From: Mess, Camie
Sent: Thursday, March 21, 2019 4:01 PM
To: amarkin@cunninghamquill.com; earonson@cunninghamquill.com; Michael Day
Cc: Werner, Jeffrey B; Lasley, Timothy G
Subject: March BAR Action - 946 Grady Avenue

BAR 17-09-02
946 Grady Avenue
Tax Parcel 310060000
Dairy Holdings, LLC, Owner/ Wendie Charles, Applicant
Amendments to COA

**CITY OF CHARLOTTESVILLE
BOARD OF ARCHITECTURAL REVIEW
STAFF REPORT
March 19, 2019**

AMENDMENT TO APPROVED CERTIFICATE OF APPROPRIATENESS SUBMISSION (APPROVED 08/21/18)

NORTH ELEVATION

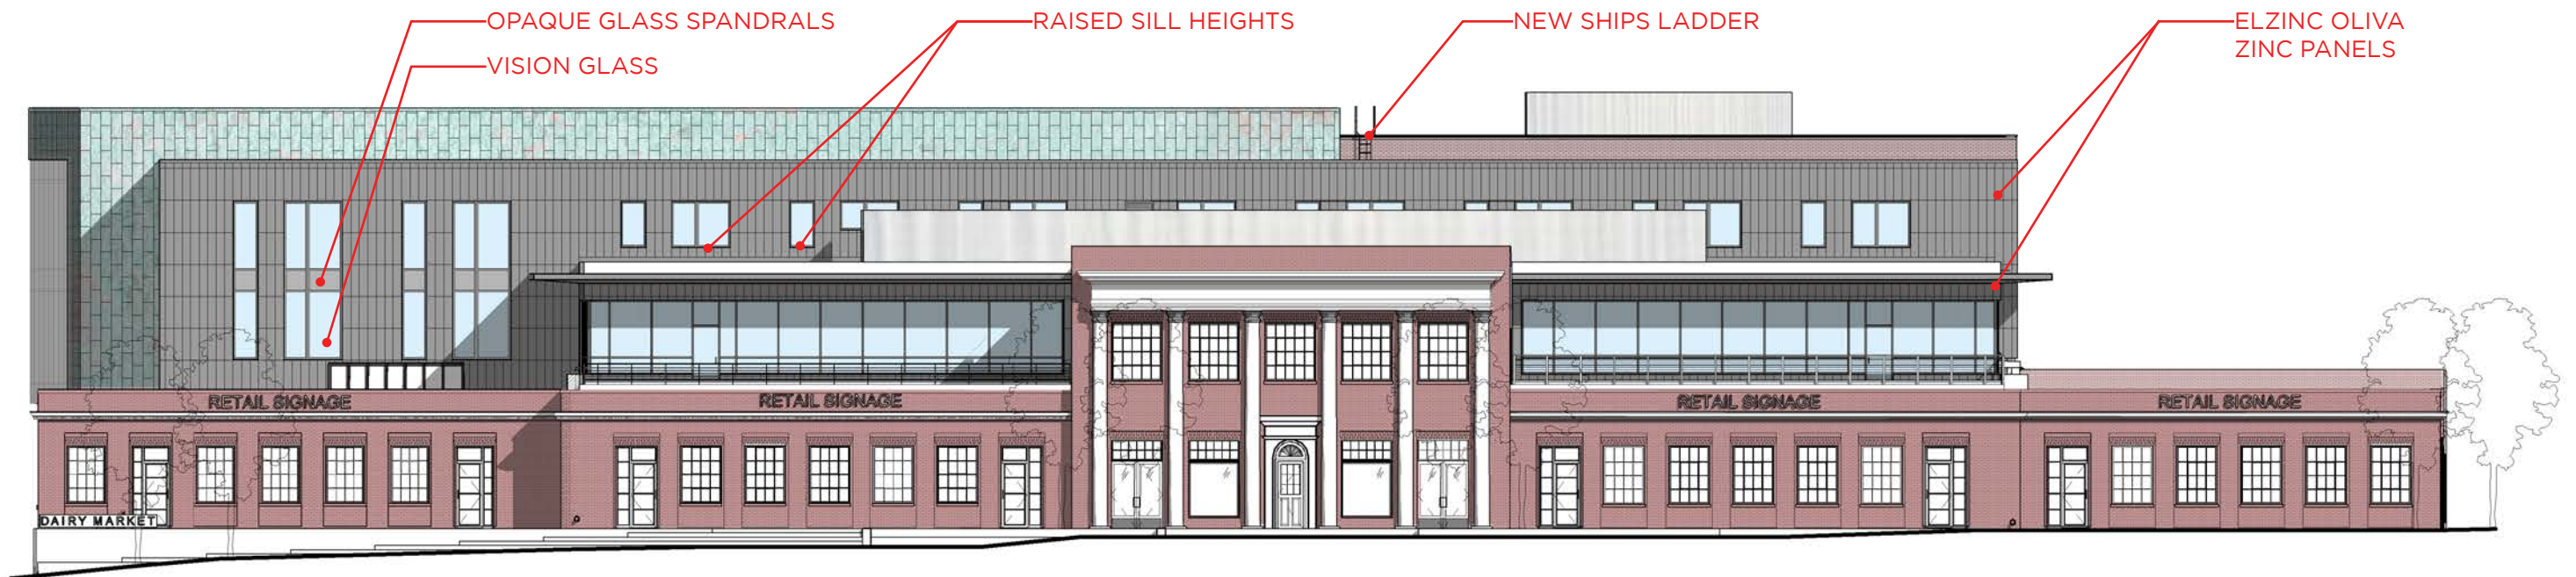
Page 3 – North Elevation

1. Zinc Panels: The approved “Rheinzink zinc graphite-grey” metal panel, will be replaced with a “elzinc Oliva” zinc panel. The panel size and configuration will not change. There is a very minimal color difference between the approved Rheinzink and the proposed elzinc panels.
2. Ships Ladder: A ships ladder has been added to allow building maintenance and service to access the lower roof of the office building addition.
3. Glass Spandrels: At the bottom of the 2nd and 3rd floor curtain wall windows, the gray opaque spandrel glass will be replaced with vision glass to allow a greater amount of daylight into the 2nd floor offices.
4. Metal Panel Punch Windows: The sill heights of the proposed punched widows have been raised to accommodate roofing/waterproofing details.

SOUTH ELEVATION

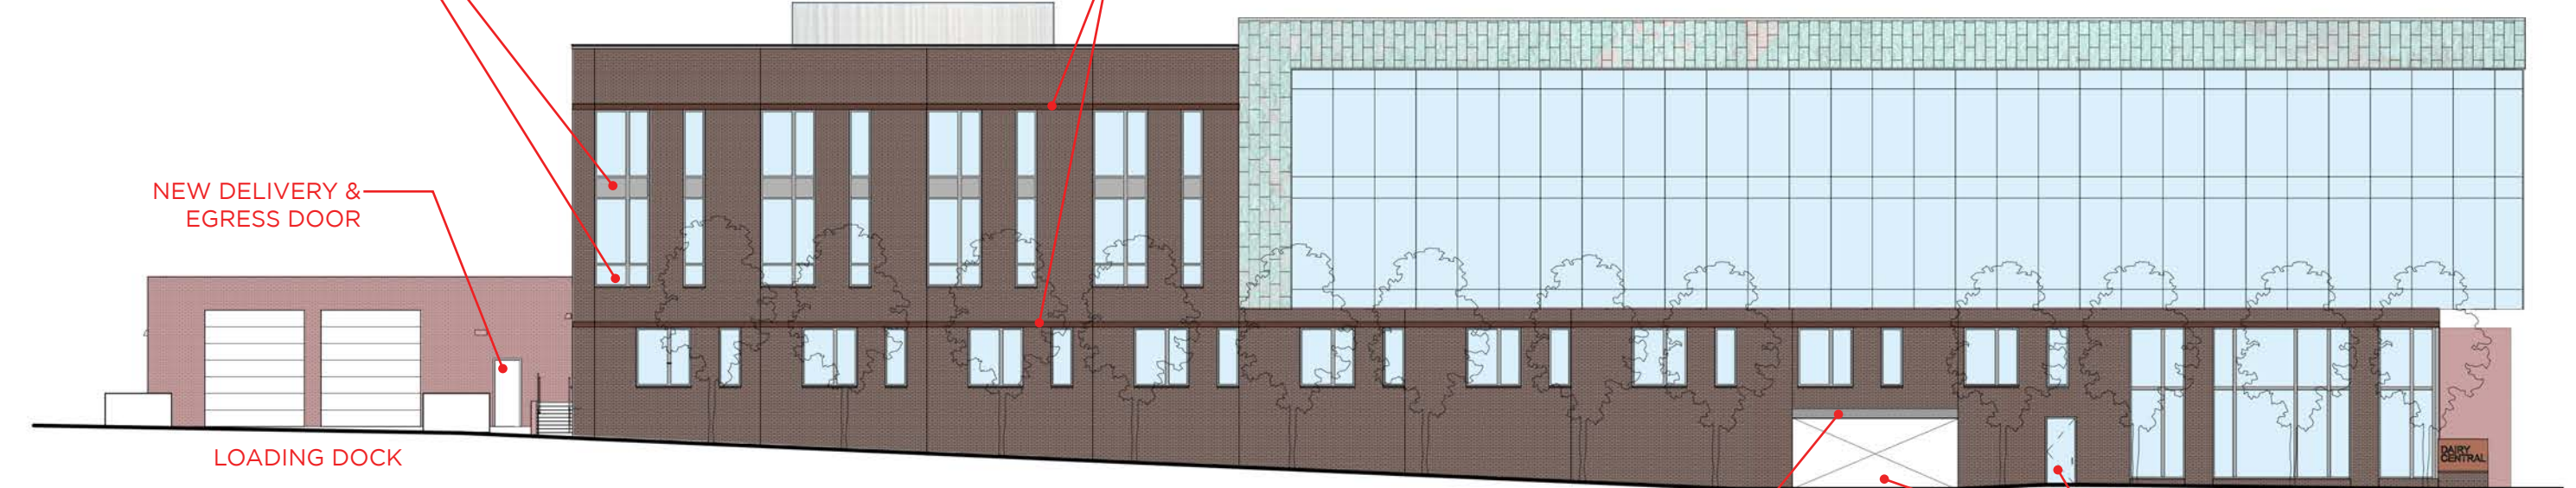
Page 4 – South Elevation

1. A continuous course of soldier coursing has been added over the length of the south elevation of the proposed office building addition.
2. Glass Spandrels: At the bottom of the 2nd and 3rd floor curtain wall windows, the gray opaque spandrel glass will be replaced with vision glass to allow a greater amount of daylight into the 2nd floor offices.

3. Garage Entry: At the garage entry, the “open grill” overhead coiling door has been removed. Over the garage entry will be a zinc metal panel header. The zinc panel will be the “elzinc Oliva”.

4. Garage Entry: Adjacent to the garage door is a new glass door. This door is being added for building egress to meet building code exiting requirements from the garage and lobby.

5. Loading Dock: An exit and delivery door has been provided at the loading dock to accommodate Postal Service deliveries and the US Postal Service’s request for a door in this location. The proposed new door will be painted white to match the loading dock overhead doors.

OPAQUE GLASS SPANDRALS

OPAQUE GLASS SPANDRALS
VISION GLASS

ELZINC OLIVA
ZINC PANEL & HEADER

EGRESS DOOR
OPENING INTO GARAGE

EAST ELEVATION

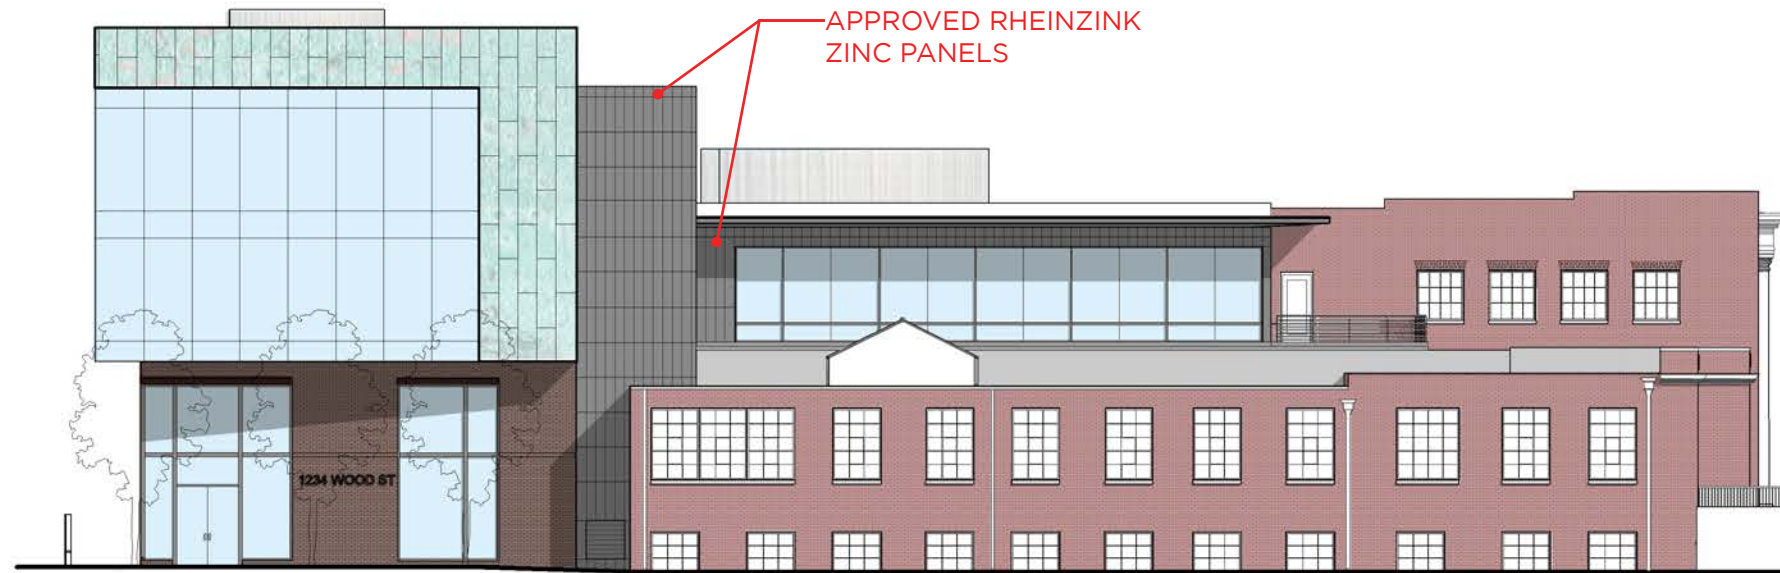
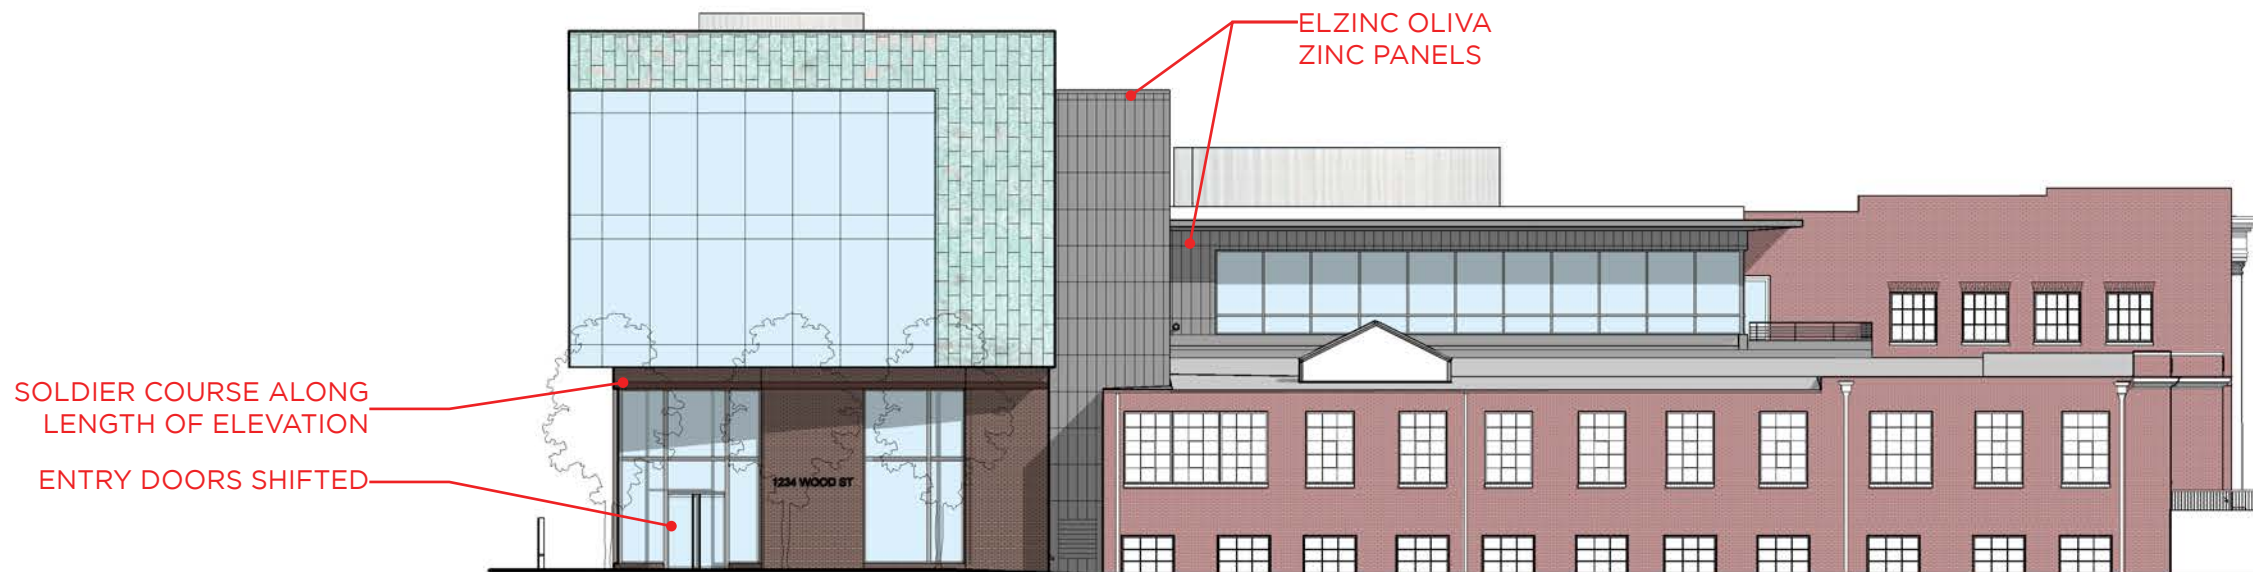
Page 5 – East Elevation

1. Zinc Panel: The approved Rheinzink zinc graphite-grey metal panel, will be replaced with a “elzinc Oliva” zinc panel. The panel size and configuration will not change. There is a very minimal color difference between the approved Rheinzink and the proposed elzinc panels.
2. Office Entry Doors: The main office entry doors has been adjusted to align with the symmetry of the office lobby.
3. A continuous course of soldier coursing has been added over the length of the west elevation of the proposed office building addition.

WEST ELEVATION

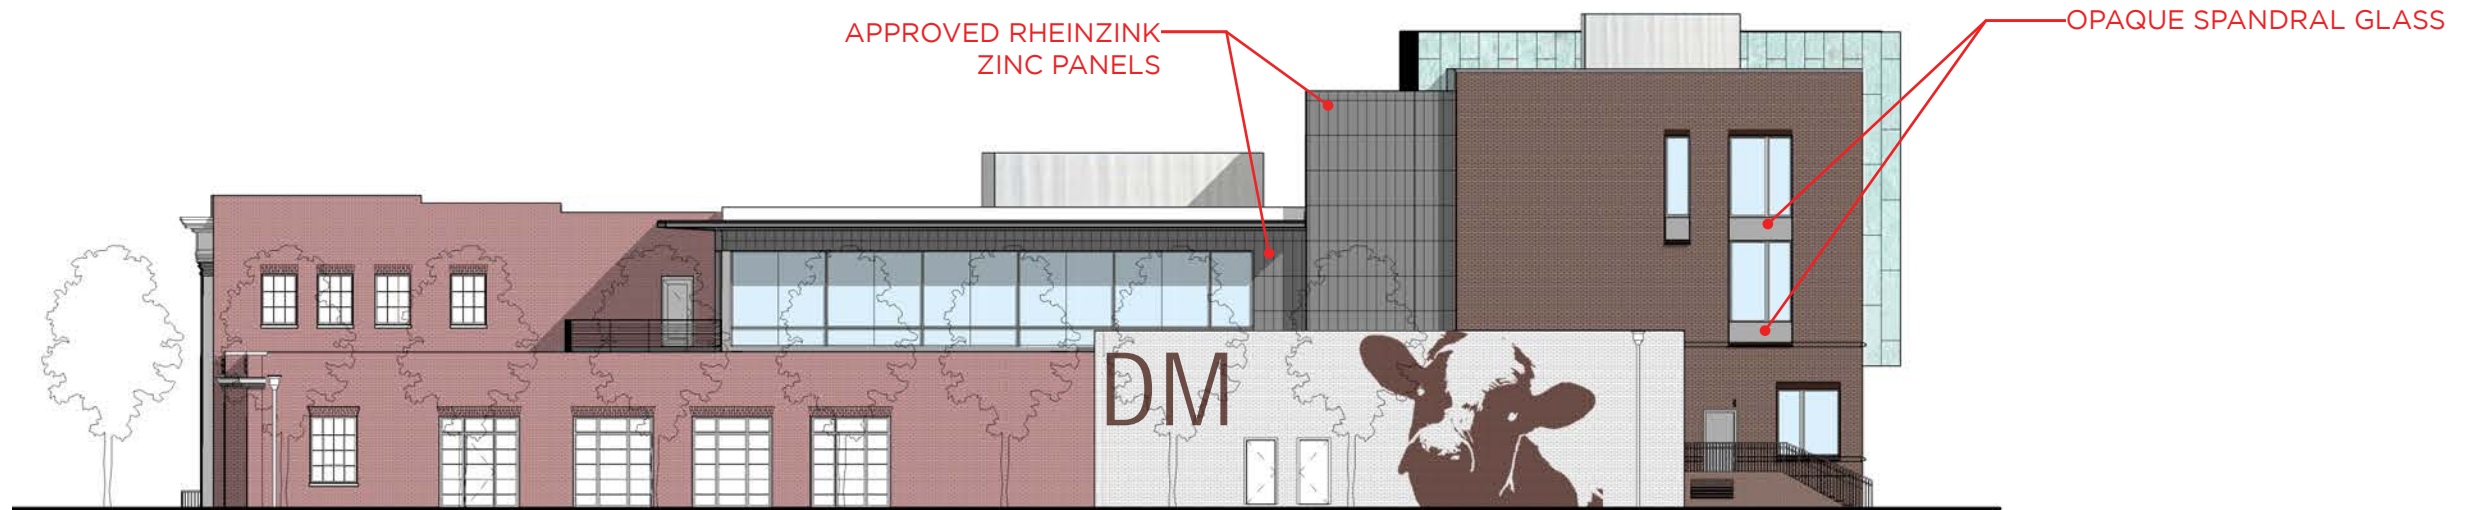
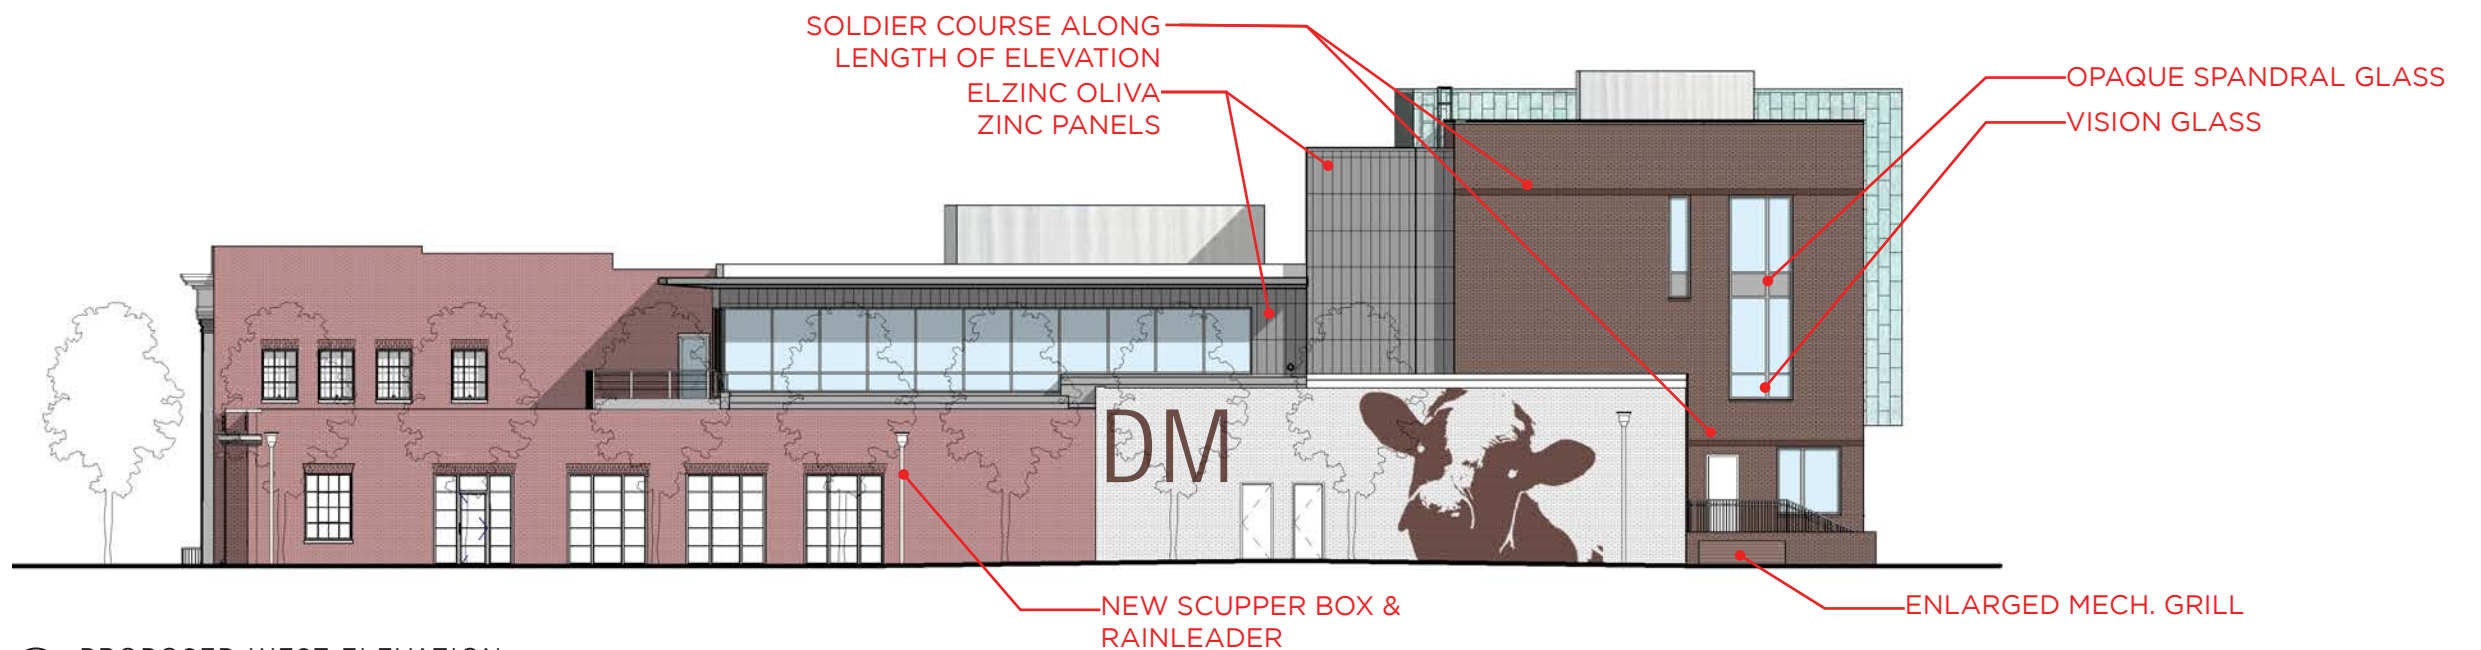
Page 6 – West Elevation

1. Zinc Panel: The approved Rheinzink zinc graphite-grey metal panel, will be replaced with a “elzinc Oliva” zinc panel. The panel size and configuration will not change. There is a very minimal color difference between the approved Rheinzink and the proposed elzinc panels.
2. A new rain leader and scupper box has been added to the west elevation to allow the roof of the dairy building to drain properly.
3. A continuous course of soldier coursing has been added over the length of the west elevation of the proposed office building addition.
